Design changes on
gas tank fundament - in Room E40.310
&
Adaptions inside the MVD-Pit

2. Adapted Design of the cryogenic apparatus outside the hall (GL01)

Adaptions on concrete fundament

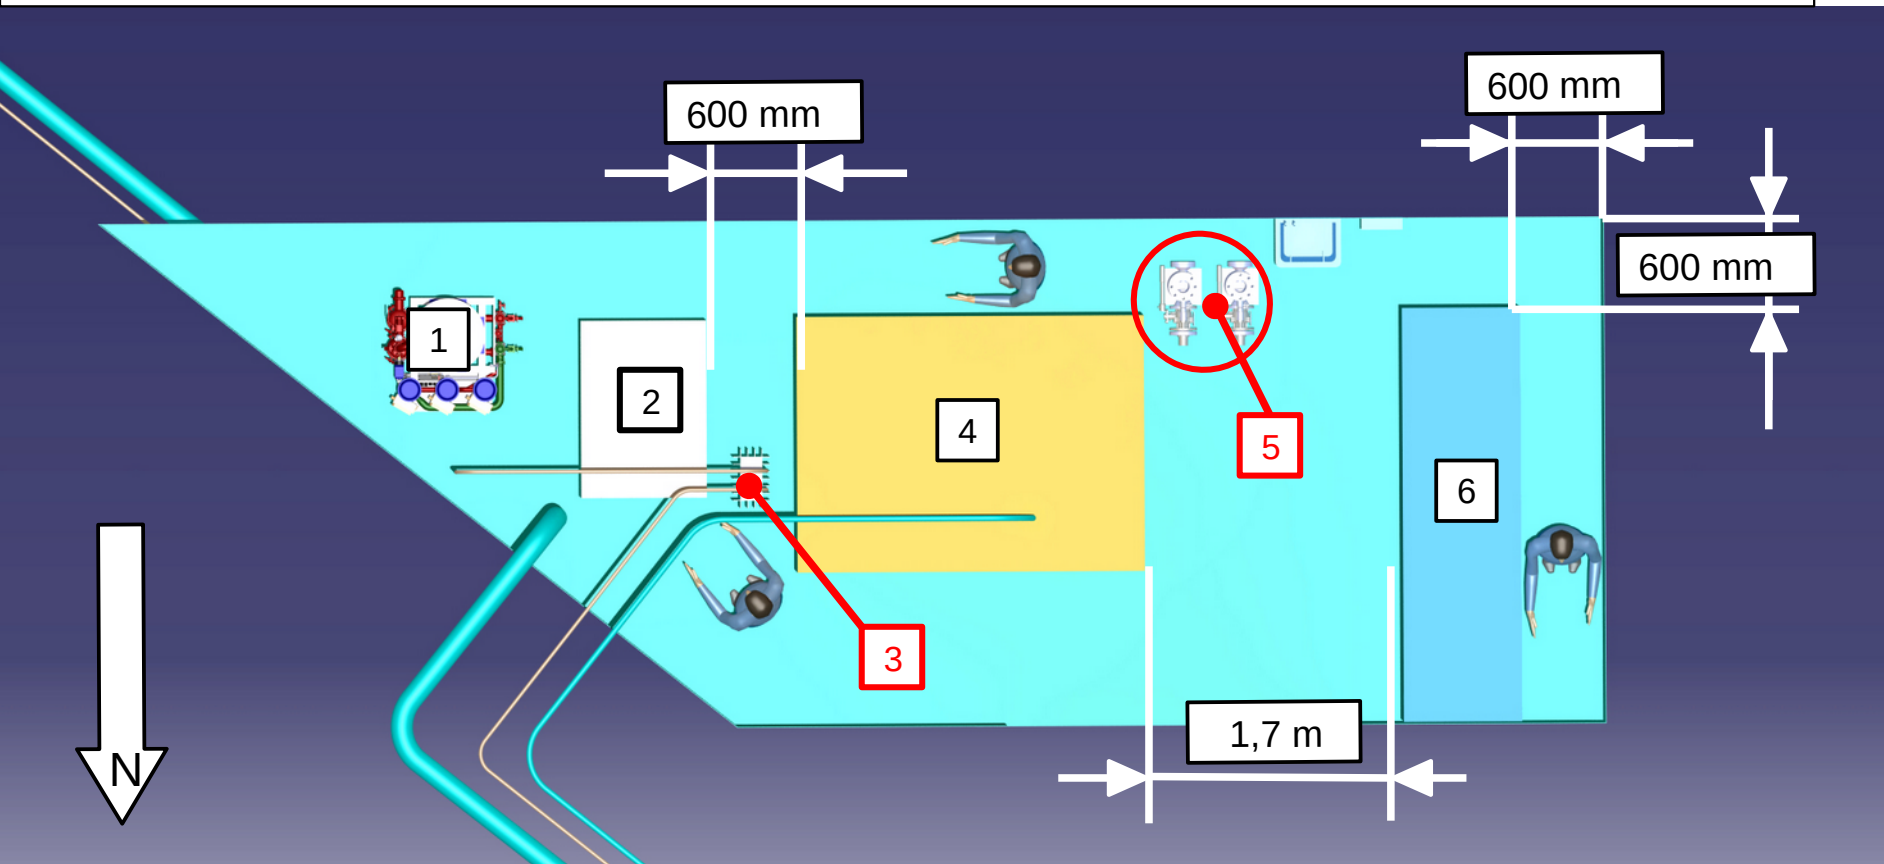
- All components moved to the north
- Extension of fundament by 4m towards south
- piping conduit running inside hall from north
- He-Shield cooling combined with 2 evaporators/heaters (Saves N₂ consumption)
- Aux.evaporator (4) keeps N₂ supply line to Valve terminal dry (no condensation)

Adaptions in Room E40.310

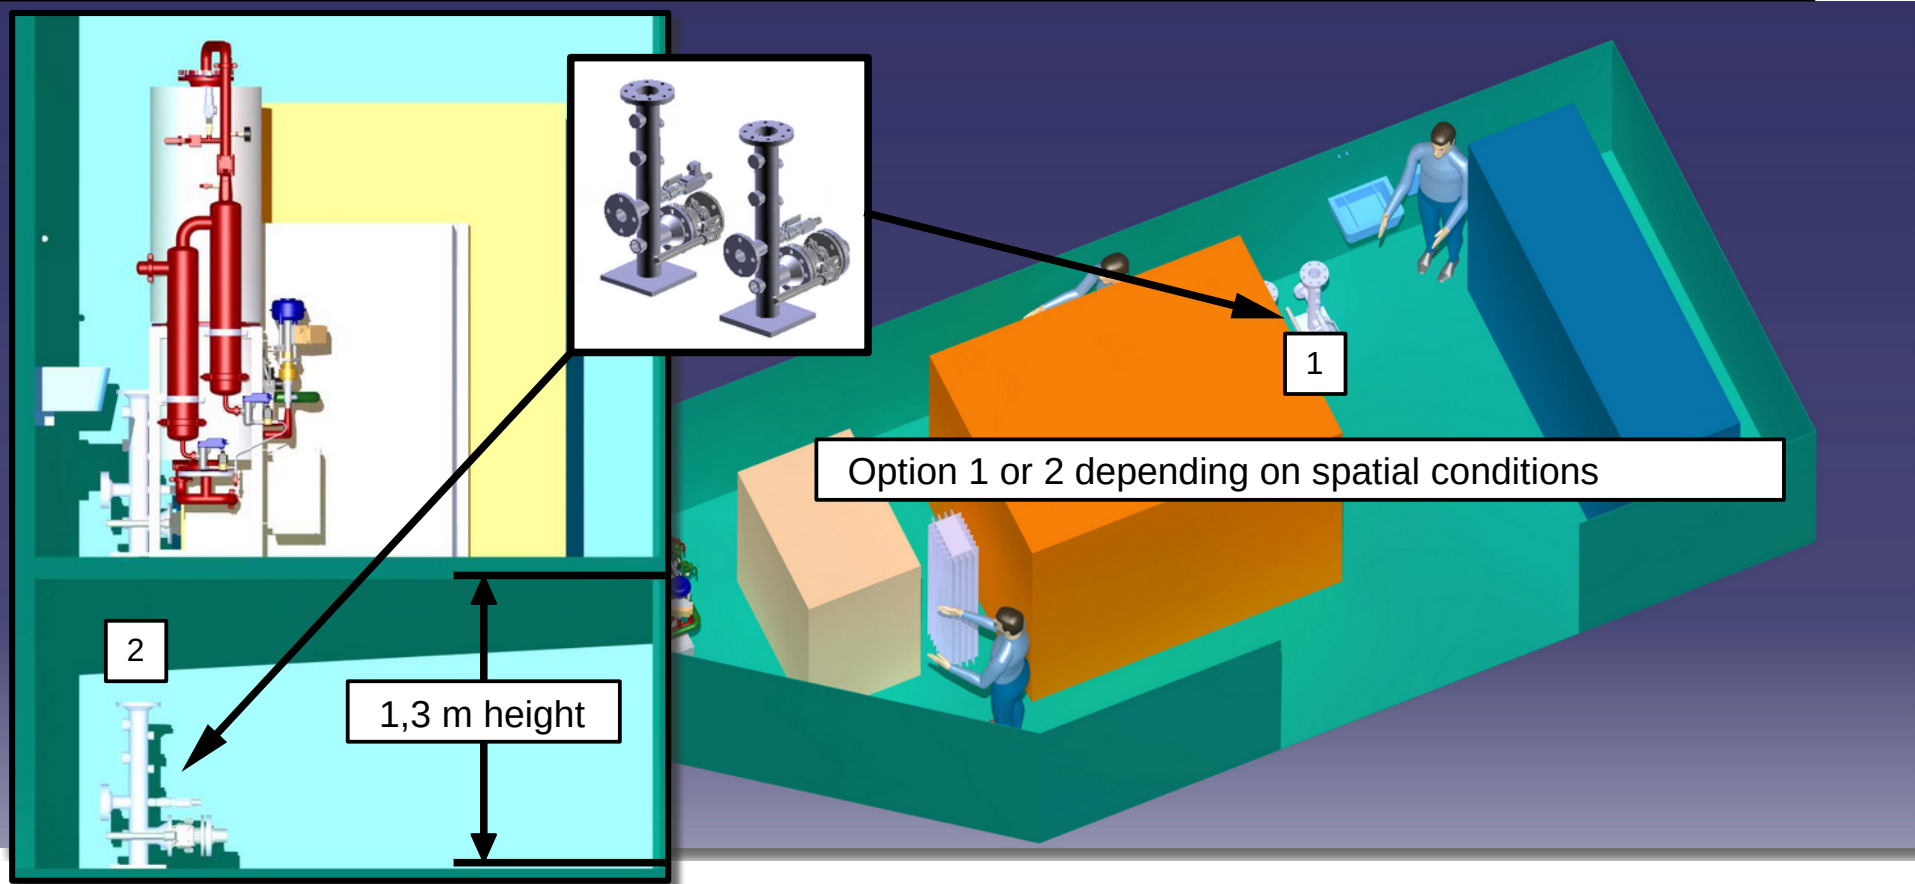
- CWU, Aux evaporator & main compressor very close to allow access to DIPOLE power converter (clearing space 600 mm)
- Main access route some 1,7m

Placement of water manifolds very close to compressor. To close ?! Entry behind compressor inhibited Installment elsewhere better

4. Alternative placement for water manifolds inside double floor in E40.310

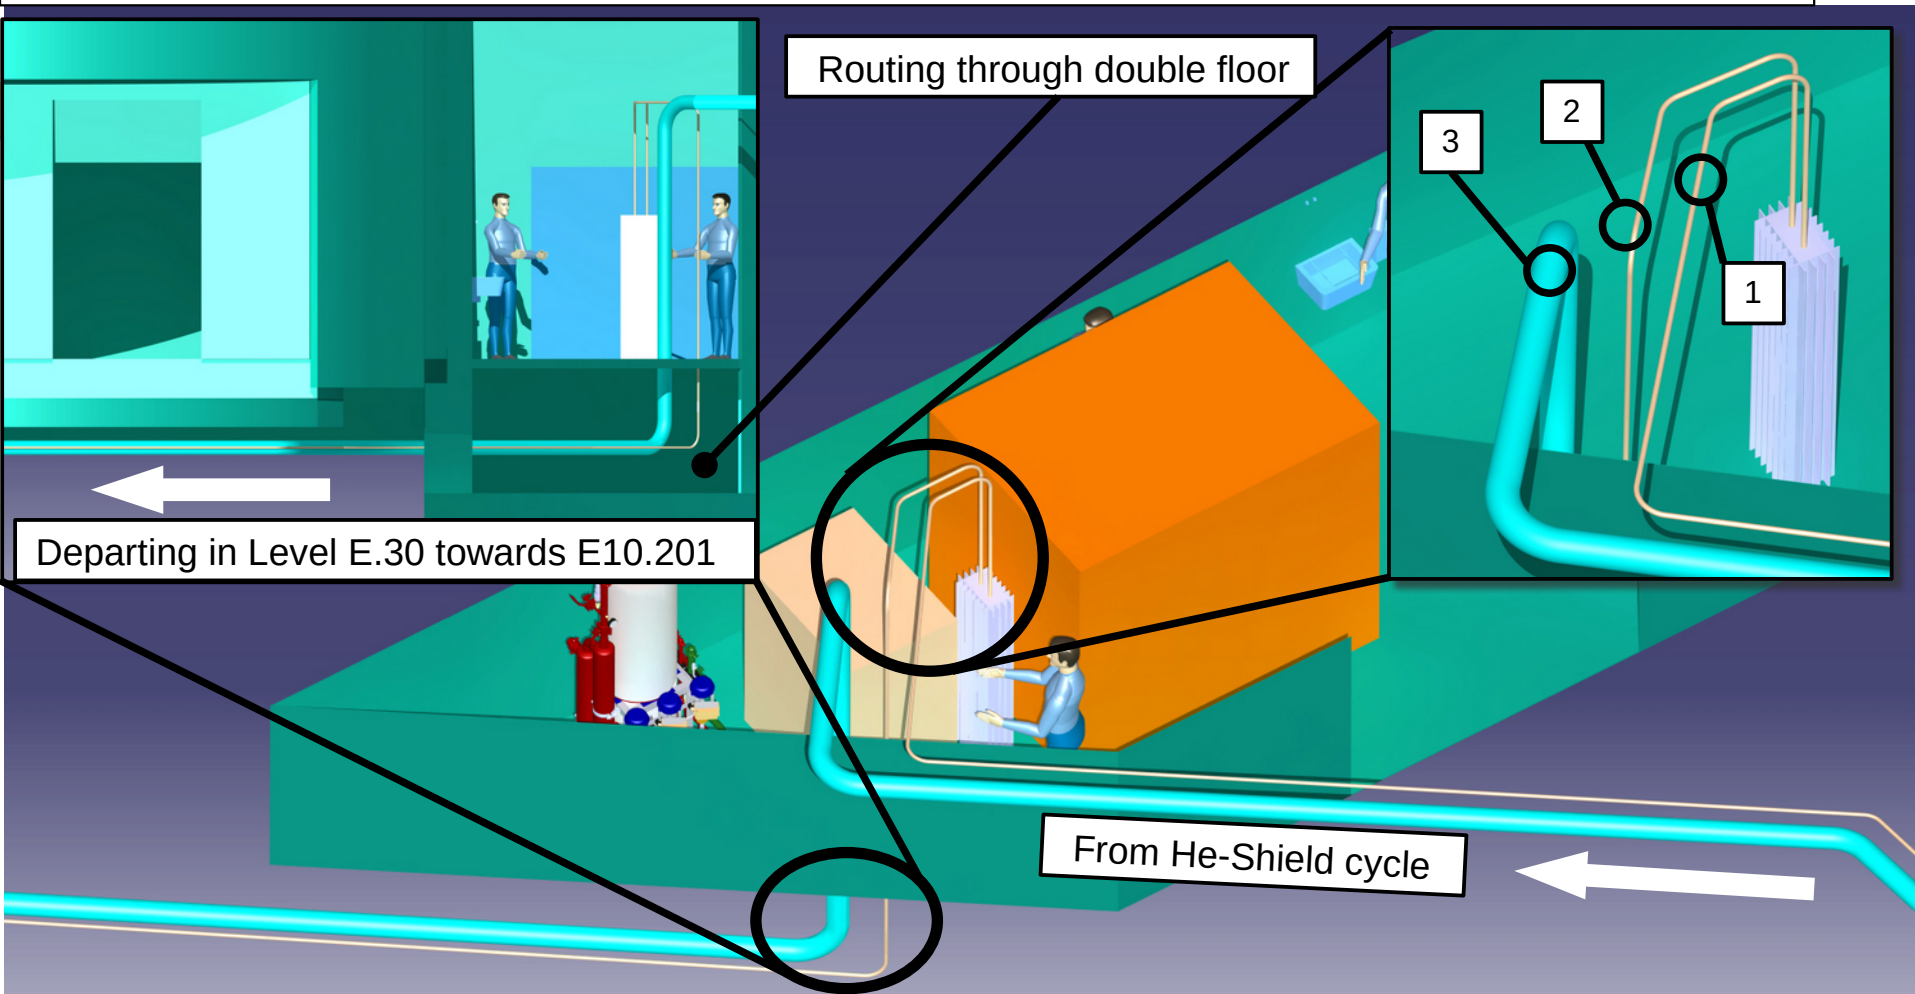
- Placement inside double floor seems better.
 - Space above available for priority installments.
 - 1,3 m height allowing for maintenance works
 - One time installment inside double floor
- (No spatial constraints yet inside)
(Hoses to be fed through service opening in floor tiles)

No maintenance works needed once securely fixed and tightened.

Routing of HE & N2-Lines

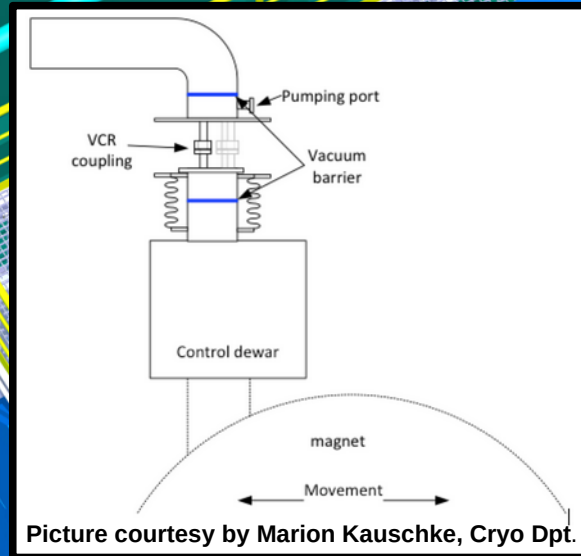
- All conduit entering the hall via room E40.310.
- lines leaving through double floor in E.30 below main truck opening

Less spatial constraints than routing in E.40

6. He-Line (de)coupling to/from Control Dewar - possible issues -

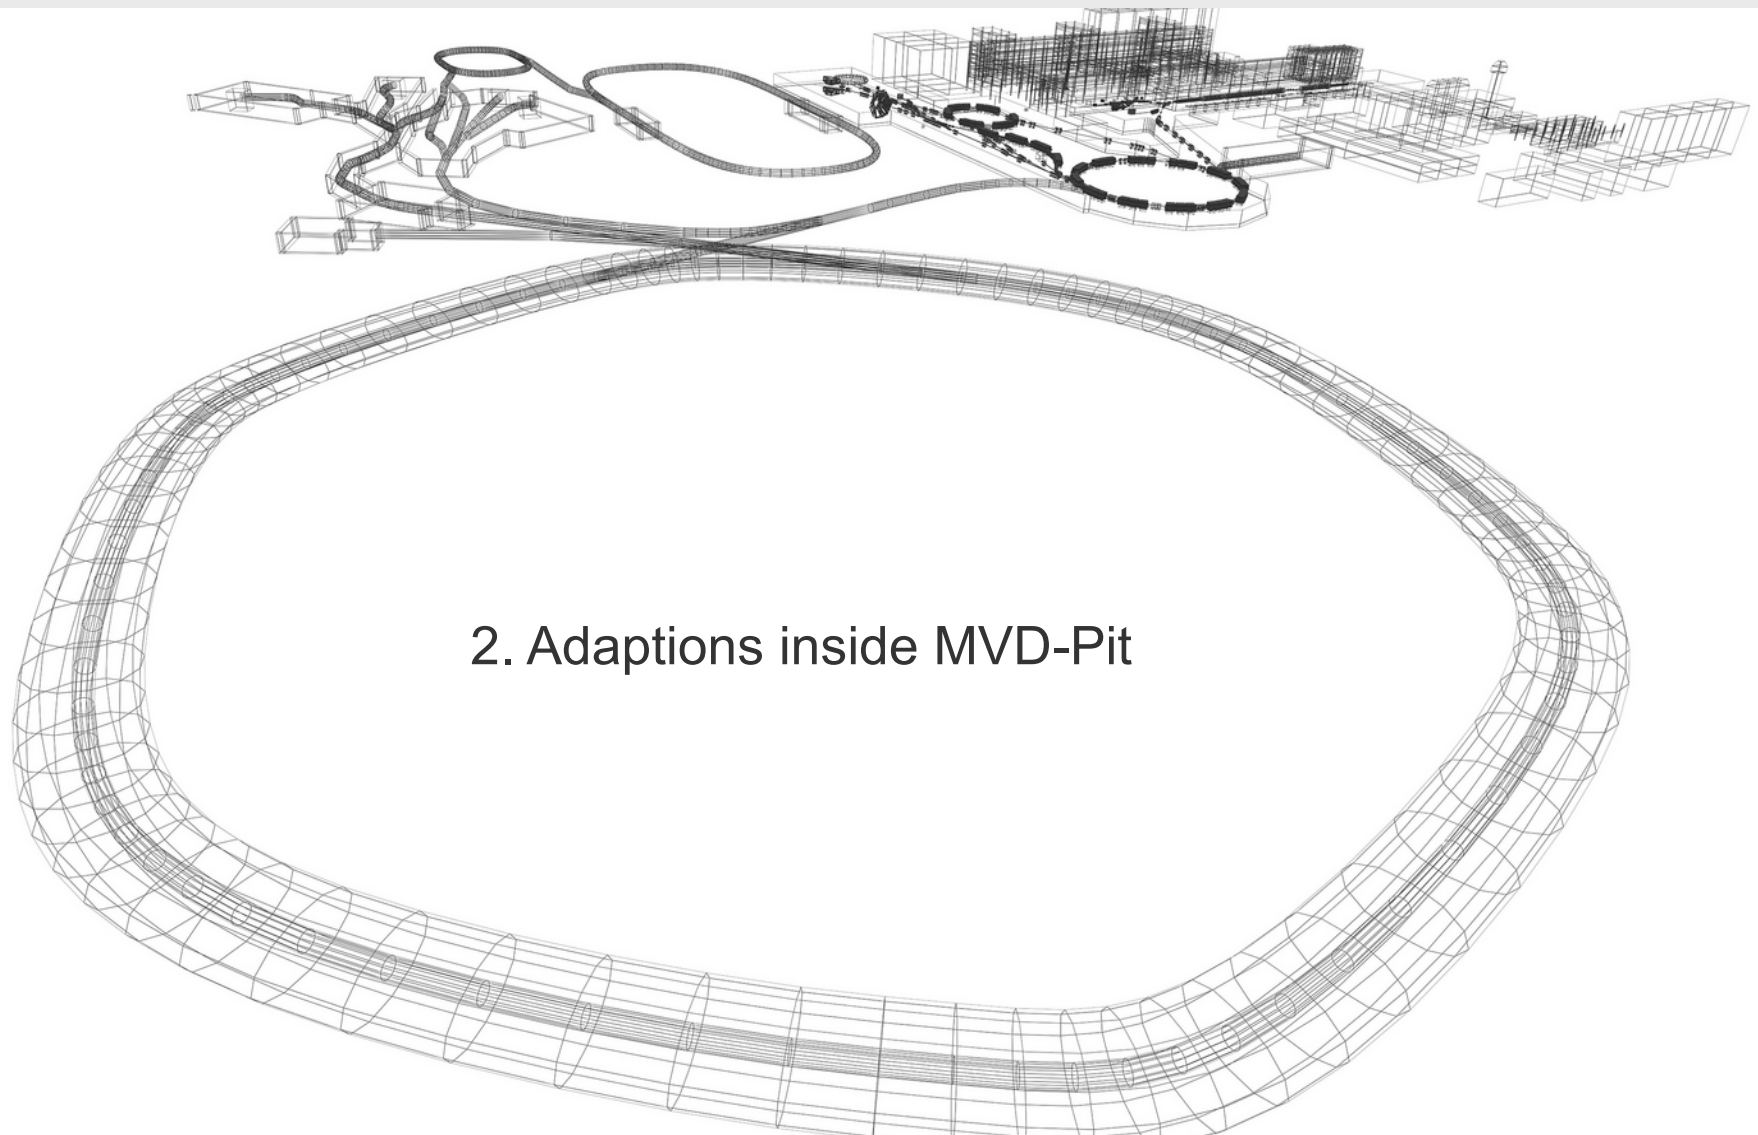
Rigid He-line arriving via **90 degree elbow** from north.

Structural elements for pipe allow no tolerances in positioning.

Any coupling under load will lead to bending stress in 90° elbow.

Degrees of freedom up- & downstream needed to couple line without constraints

- Helium may blow off
- damage to VCR Connection ?

Can flexible connection hoses be used instead of proposed rigid line by BINP ?

8. Situation inside MVD-Pit - Assumptions and Iterations -

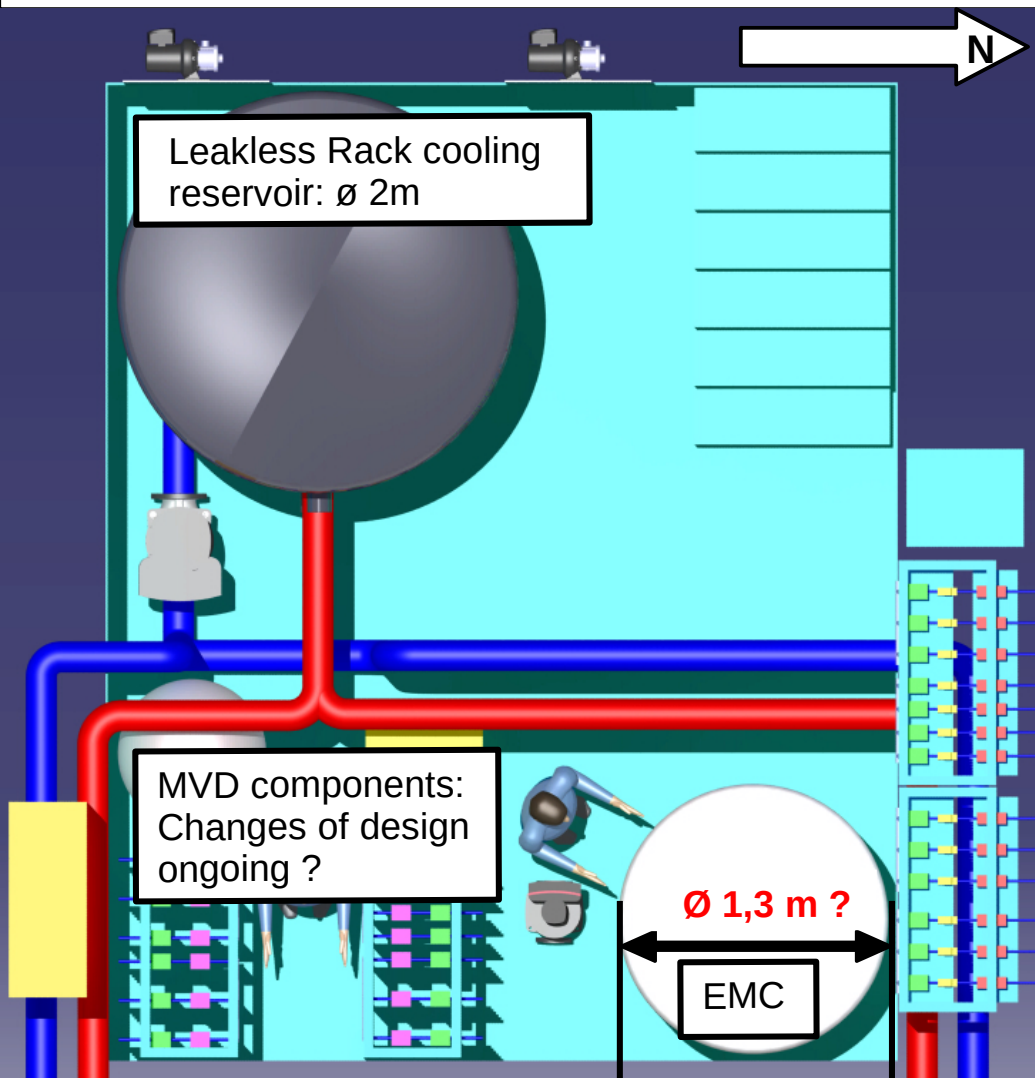
- isolation cover for EMC assumed with with bigger $\varnothing$ 0,3m + tank = 1,3 m
- extra line for supply of dry air inside tank isolation asked for.

Remark: Where to get a continuous stream of dry air from ?
No plans to employ an air compressor or turbine (lack of space & costly) !

Question: How can condensation be avoided short of using an extra air compressor ?
